Comment responses D1.0 San Antonio, Texas November 2014

Chris DiMinico - MC Communications/Panduit
cdiminico@ieee.org

Draft 1.0 comments – 97.4.4.1.4 Differential to common mode conversion

Conversion Loss – proposal

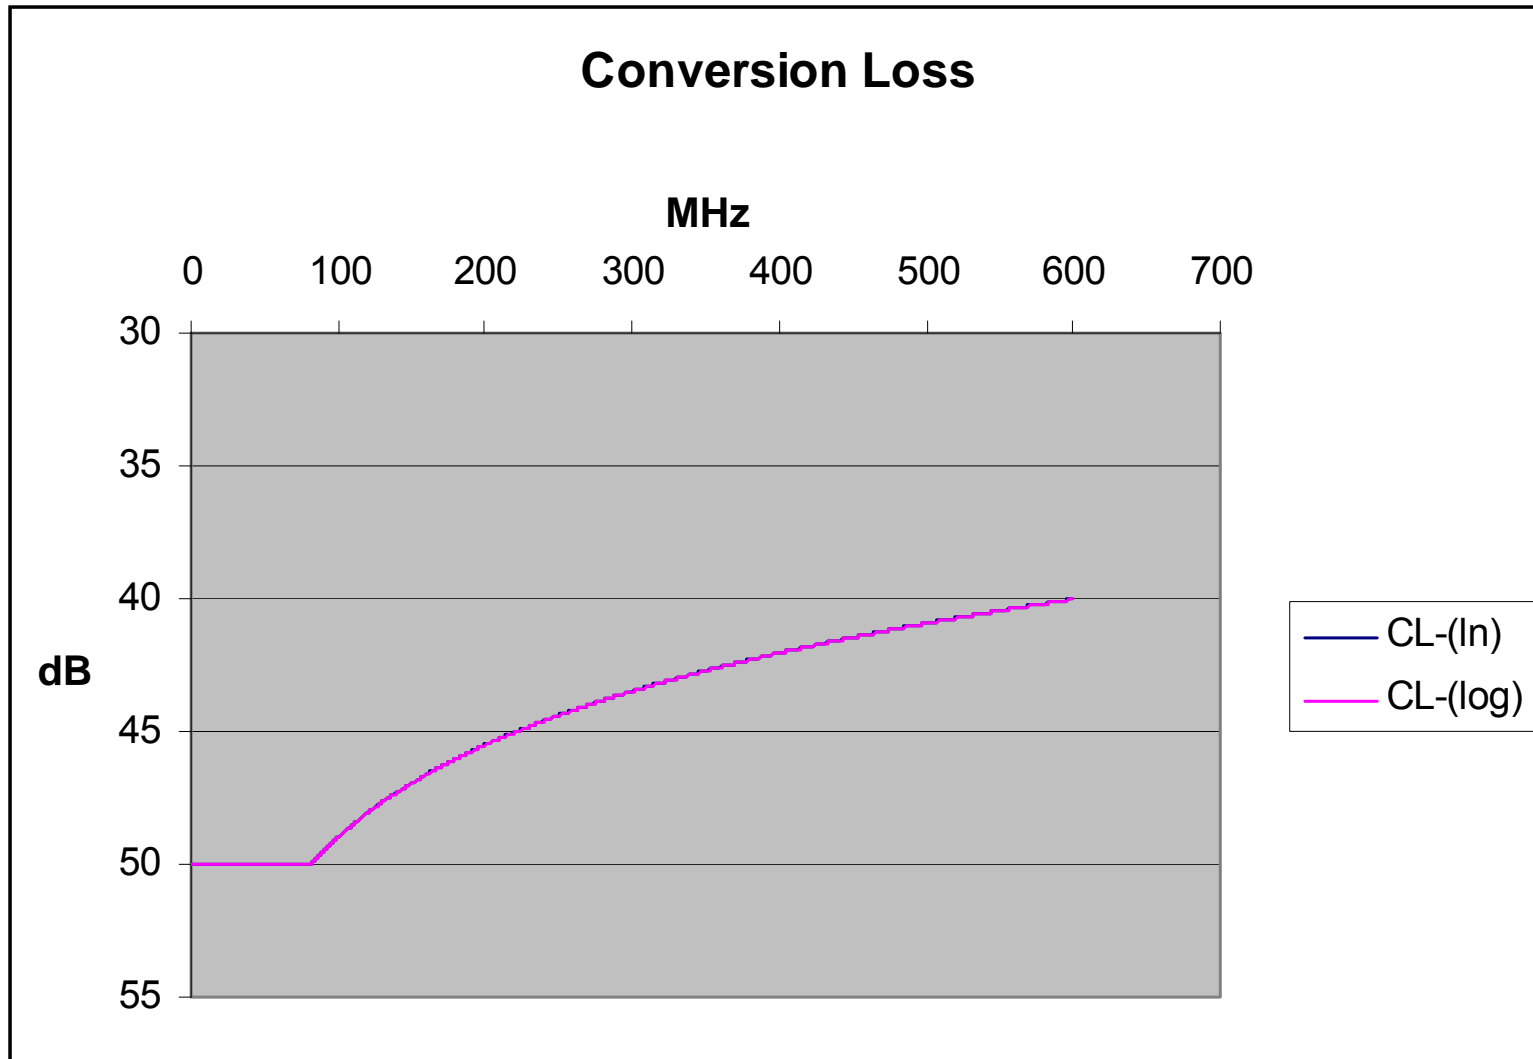
Cl 97 **SC 97.4.4.1.4** **P 28** **L 24** # **51**
 DIMinico, Christopher MC Communications
Comment Type **T** **Comment Status** **D** **Equation (97-3)**
 change equation 97-3 to use log10 and yield positive values (loss).
SuggestedRemedy
 Change equation 97-3 to ConversionLoss $\geq [50 - 10 \log_{10}(f - 80)]$ dB $[72 - 11.51 \log_{10}(f - 80) - 600]$ dB where f is frequency in MHz.
Proposed Response **Response Status** **W**
 PROPOSED ACCEPT IN PRINCIPLE.
 Needs alignment with comment #27

Cl 97 **SC 4.4.1.4** **P 28** **L 26** # **27**
 Chini, Ahmad Broadcom
Comment Type **ER** **Comment Status** **D** **Equation (97-3)**
 Equation (97-3) needs to be corrected for loss instead of gain. Replace "ln" with equivalent log10 to be consistent with other equations as well.
SuggestedRemedy
 Use the equation in the attached document.
Proposed Response **Response Status** **W**
 PROPOSED ACCEPT IN PRINCIPLE.
 Reference: chini_3hp_01_1114.pdf - needs alignment with comment #50

Editorial Note (to be removed prior to publication): Equation (97-3) needs to be converted into conversion loss.

Correction:
$$\text{ConversionLoss}(f) \geq \begin{pmatrix} 50 & 10 \leq f \leq 80 \\ 72 - 5 \ln(f) & 80 < f \leq 600 \end{pmatrix} \text{ dB}$$

Recommendation: → convert *ln* to *log* to be consistent with all other equations

$$5 \cdot \ln(f) = 5 \cdot \ln(10) \cdot \log(f) = 11.51 \cdot \log(f)$$

→ resulting equation:
$$\text{ConversionLoss}(f) \geq \begin{pmatrix} 50 & 10 \leq f \leq 80 \\ 72 - 11.51 \cdot \log(f) & 80 < f \leq 600 \end{pmatrix} \text{ dB}$$
